Products: K-Series Product Hangers

Release Date: March 24, 2023

K-Series Product Hangers

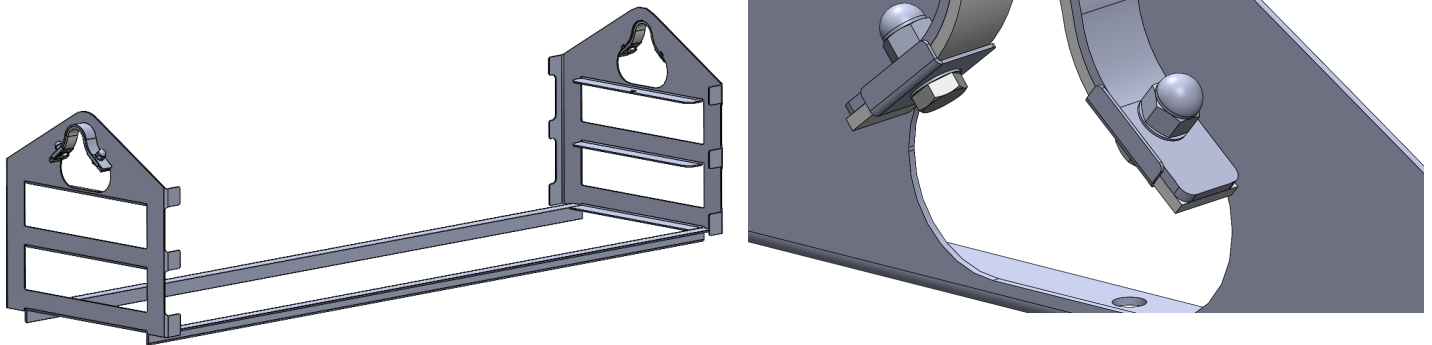
Product hangers for the models listed above have been redesigned to be similar to the product hangers in current production models. The redesign increases manufacturing efficiencies, which will reduce the lead time and list price of the hangers. The redesign also allows mobile pins and clips to be utilized with the hangers (see Product Bulletin SPProd-009.4). The new stock code for the hangers are as follows:

Once the remaining quantity of hangers with the previous design are sold, the redesigned hanger will be the only option for the older smoker models above with rotisserie wheels that have metal hanger stubs.

The replacement Teflon (310002) and rack retainer kit (993008) remain the same as the previous design.

Model	Product Hanger
SPK-280	994033
SPK-500	994034
SPK-700	994035
